SYSTEM: ADVANCED LIGO

SUB-SYSTEM: AOS

PART NAME: OPTICAL LEVER PIER WELDMENT PROTOTYPE

D0900657 AdvLIGO AOS Optical Lever Pier Weldment Prototype PART PDM REV: X-018 DRAWING PDM REV: X-017

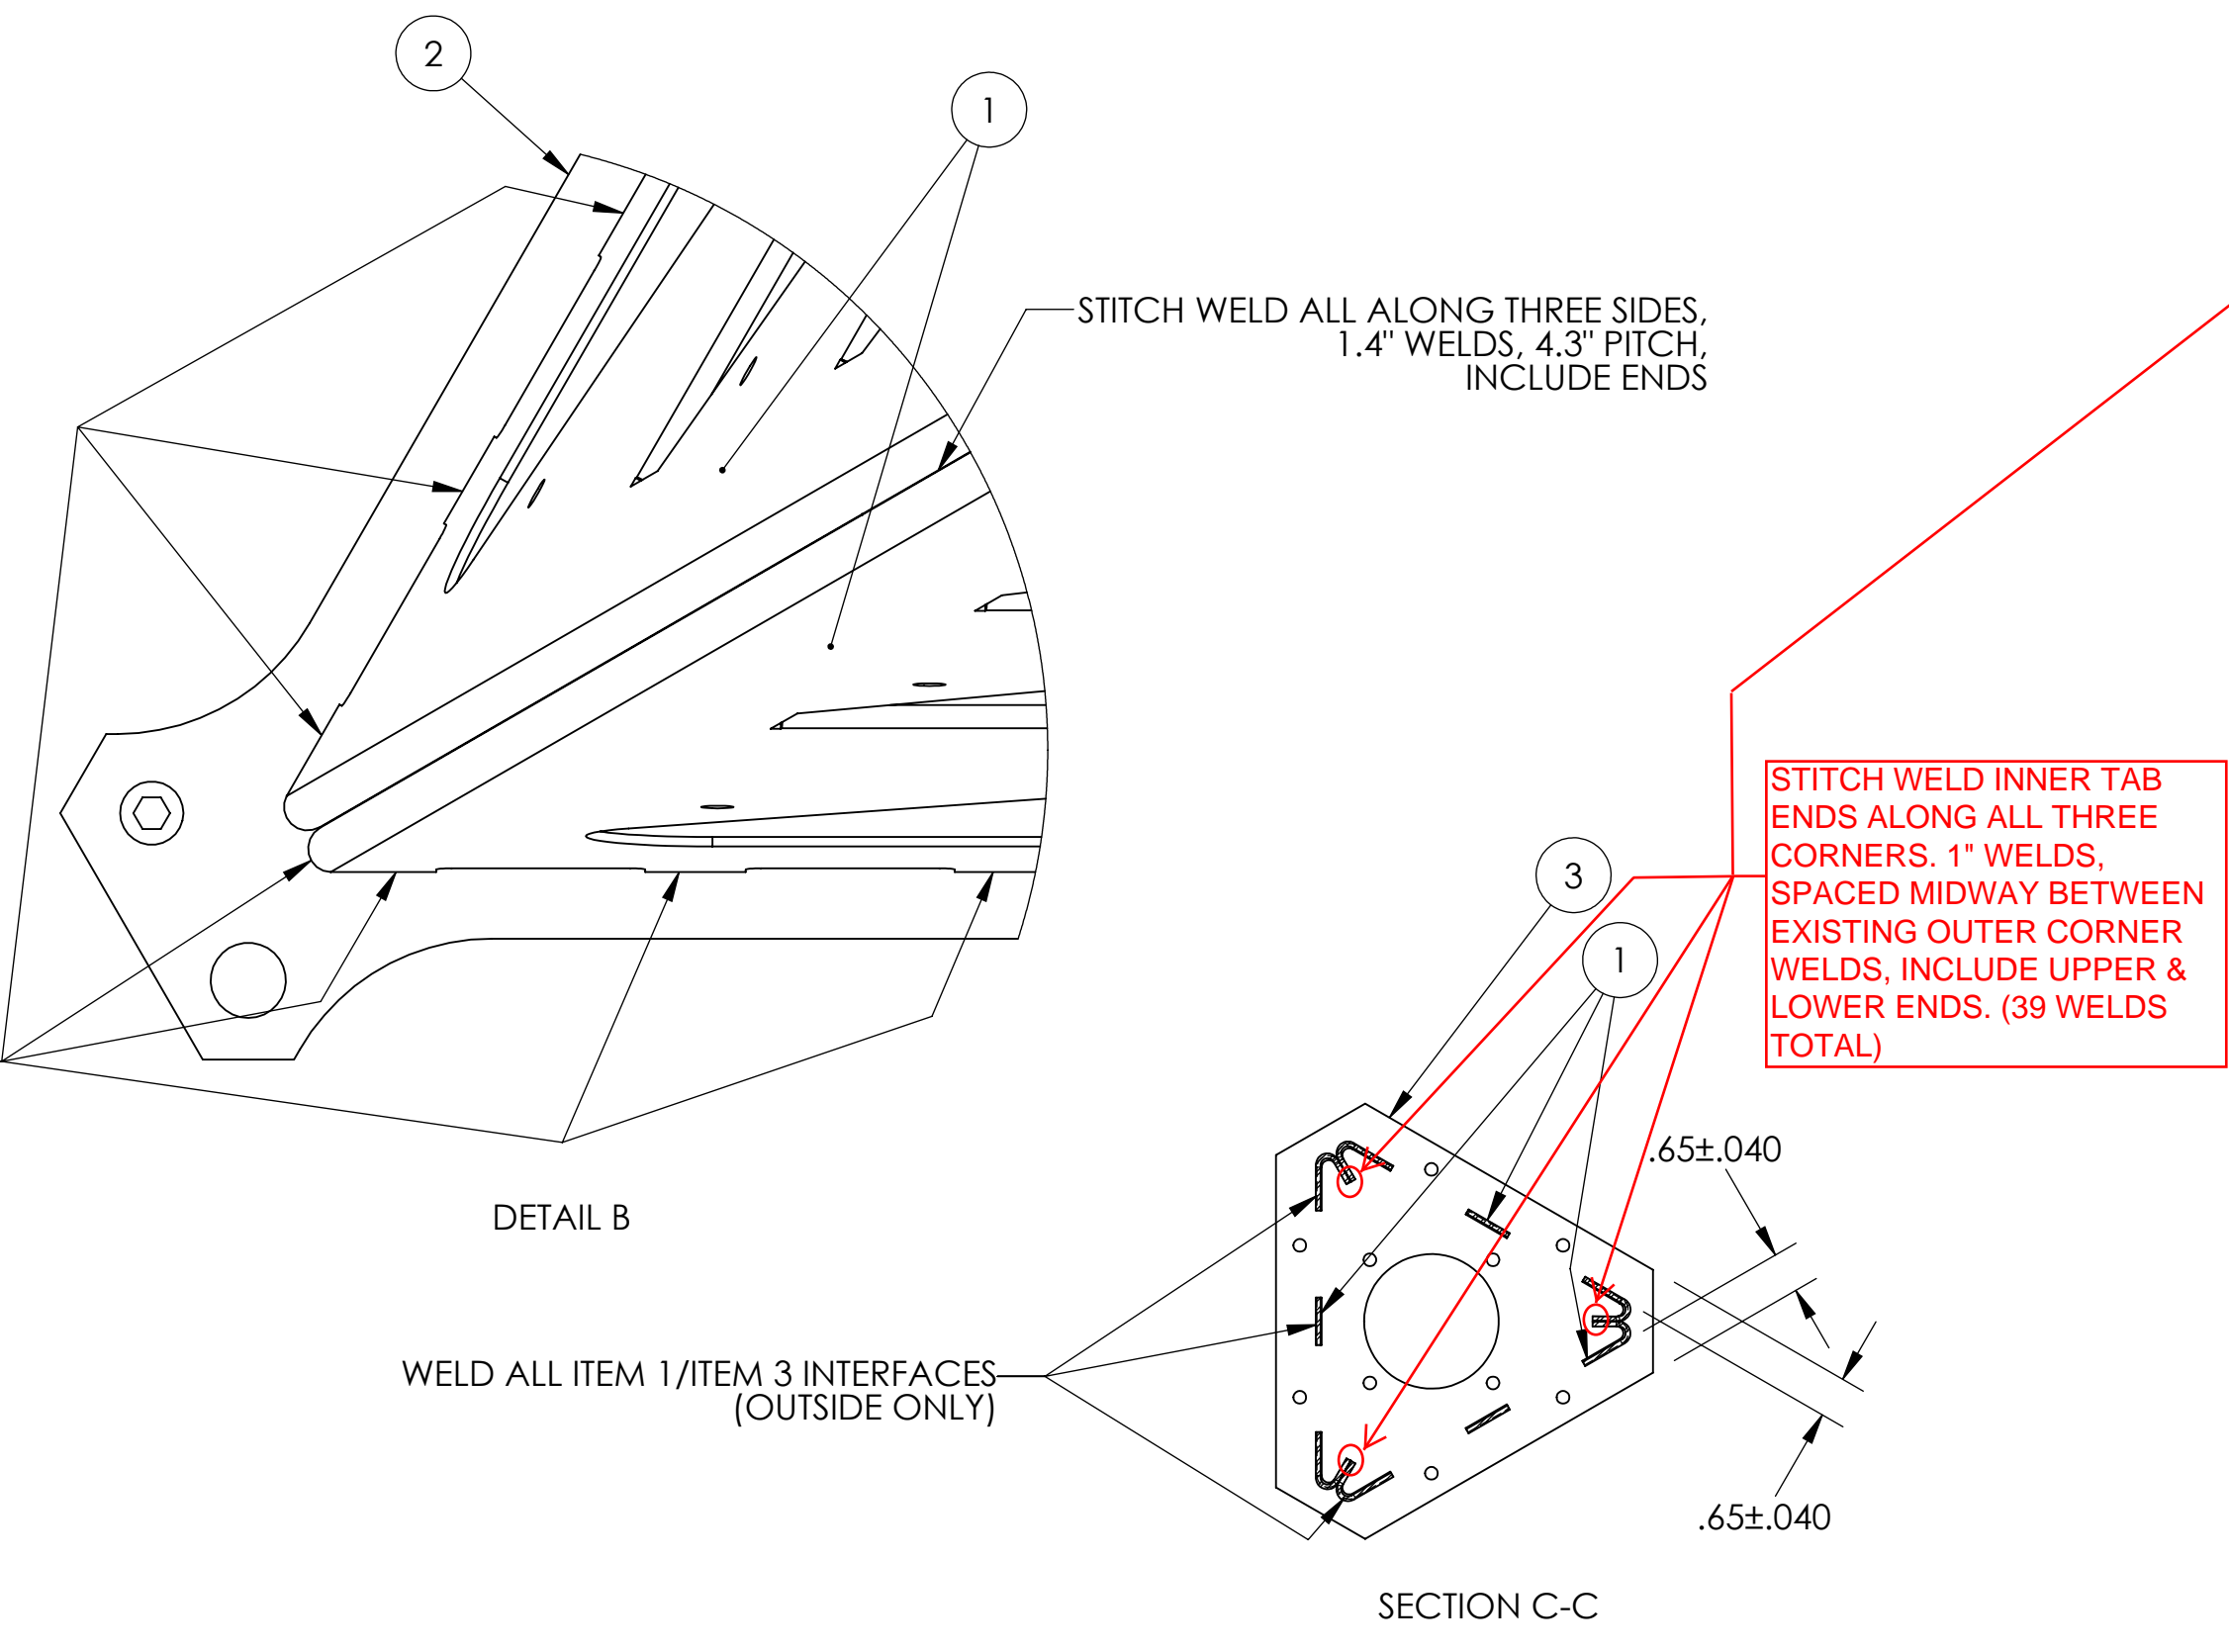
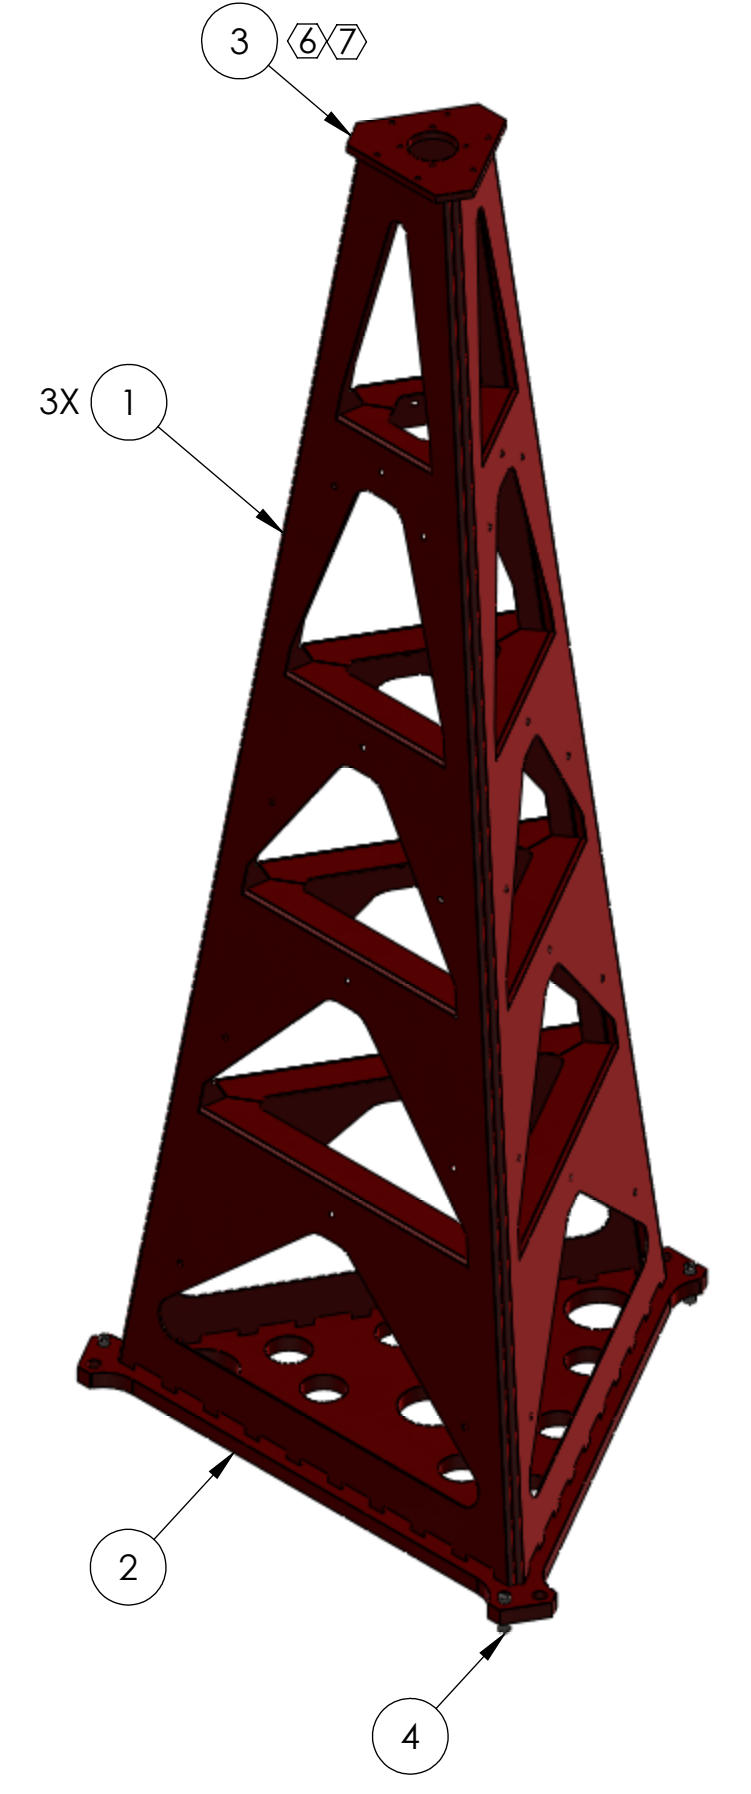
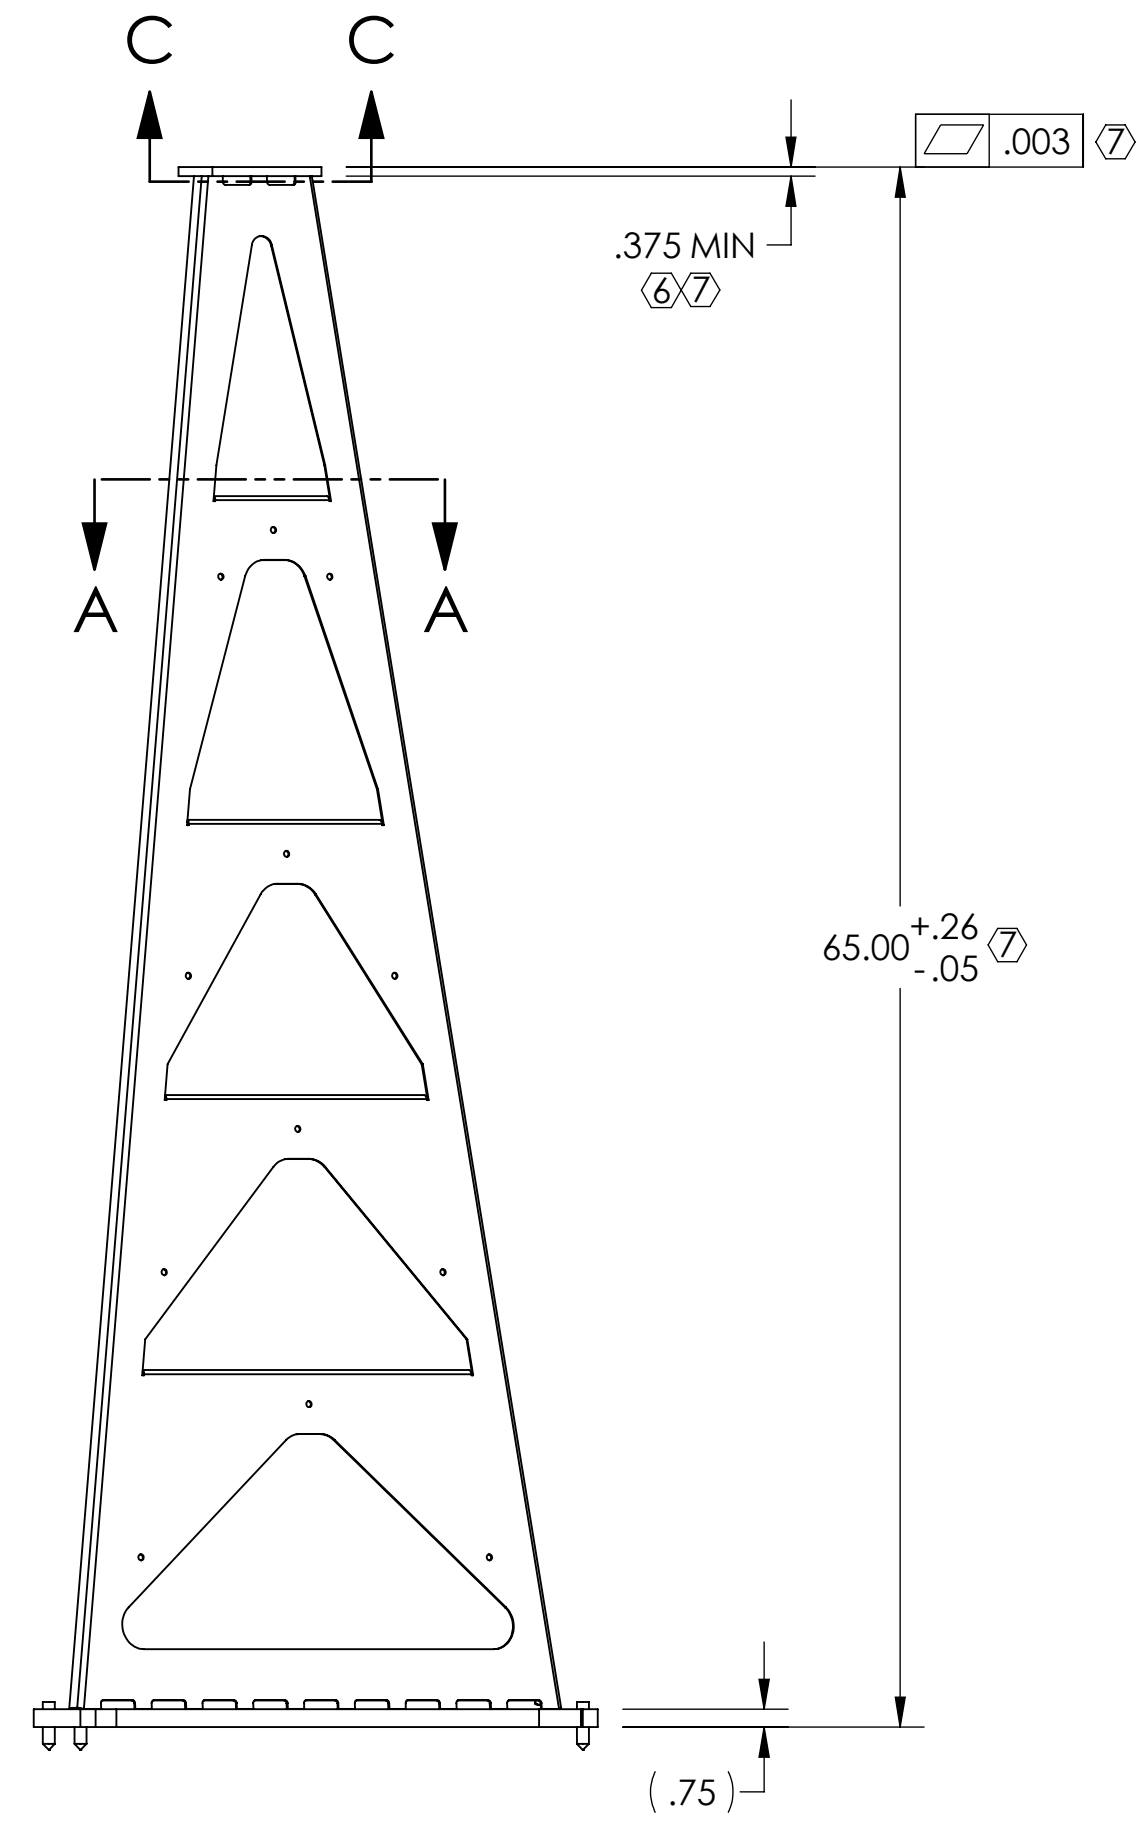
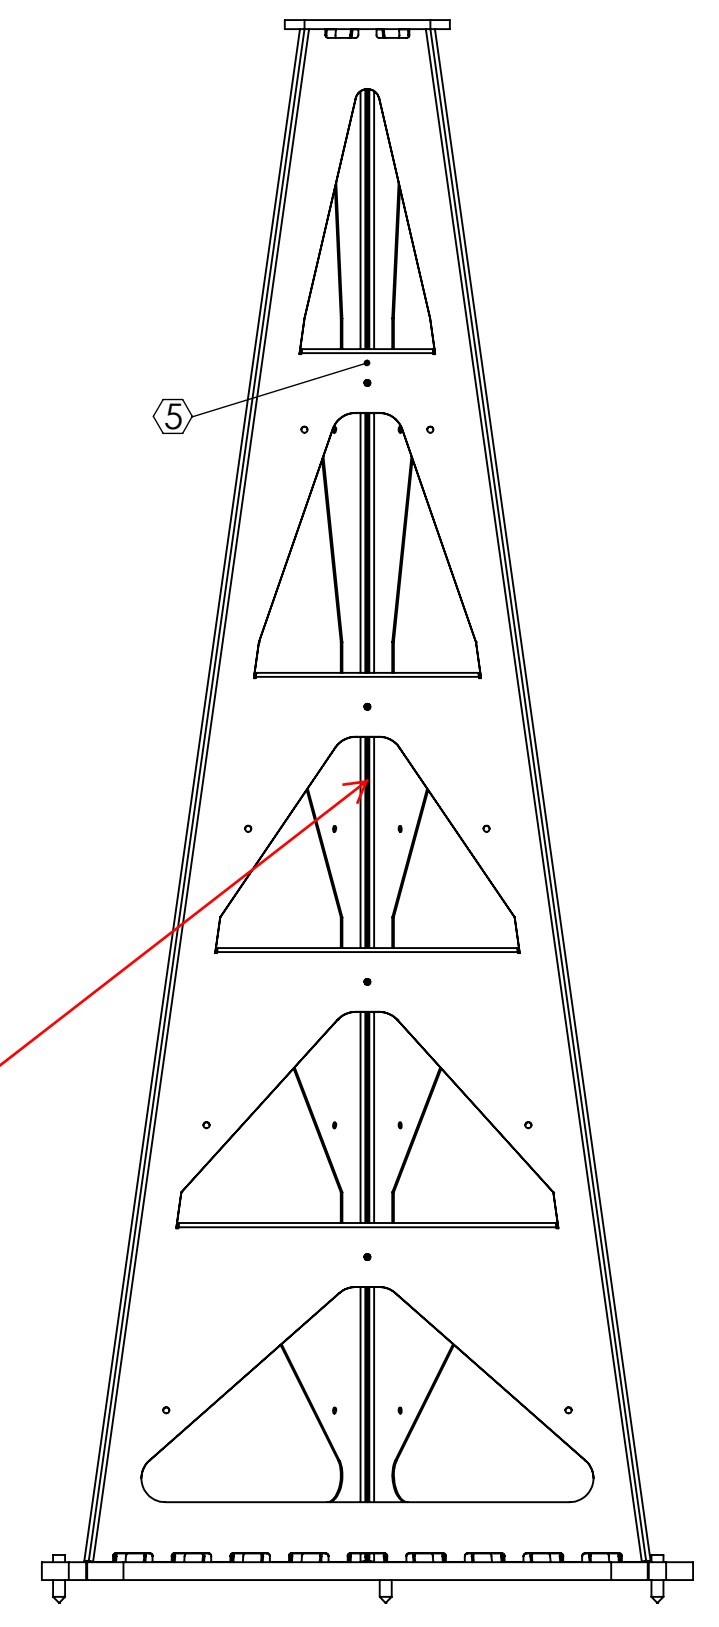
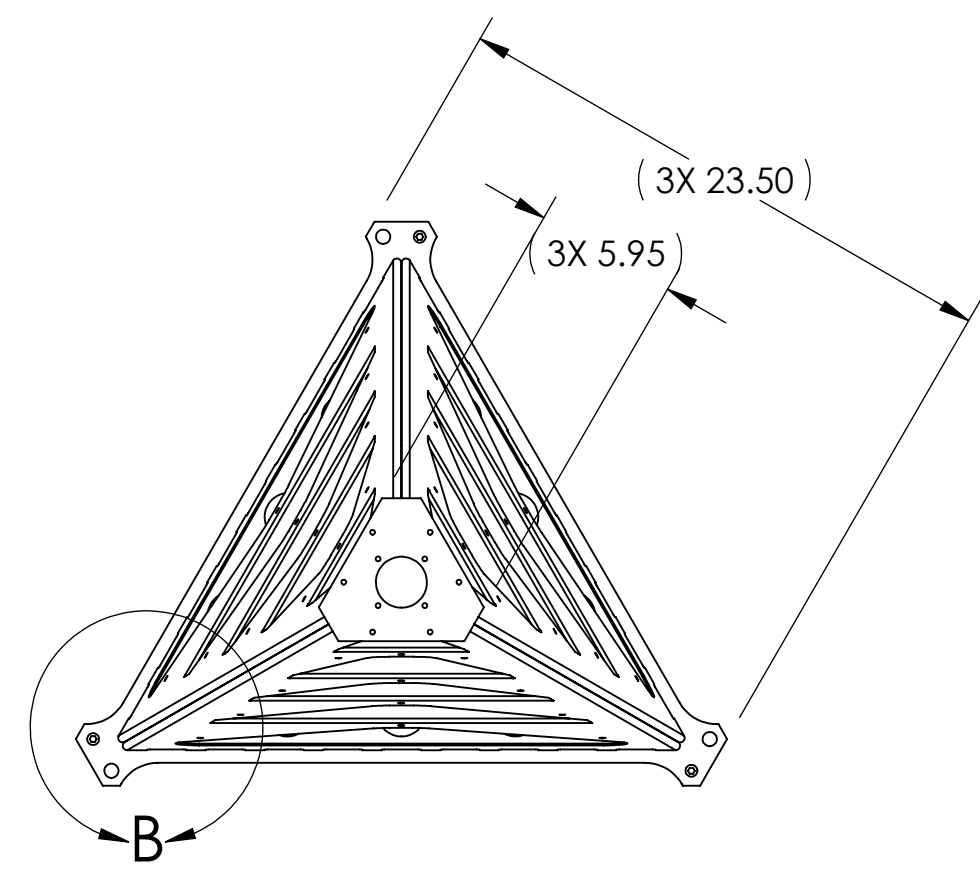
ADD WELDS ALONG FAR SIDES OF BUTT JOINTS. 12 PLACES

WELD ALONG BUTT JOINT 12 PLACES

STITCH WELD ALL ALONG THREE SIDES. 1.4" WELDS, 4.3" PITCH, INCLUDE ENDS

STITCH WELD INNER TAB ENDS ALONG ALL THREE CORNERS. 1" WELDS, SPACED MIDWAY BETWEEN EXISTING OUTER CORNER WELDS, INCLUDE UPPER & LOWER ENDS. (39 WELDS TOTAL)

WELD ALL ITEM 1/ITEM 2 INTERFACES (OUTSIDE ONLY)

WELD ALL ITEM 1/ITEM 3 INTERFACES (OUTSIDE ONLY)
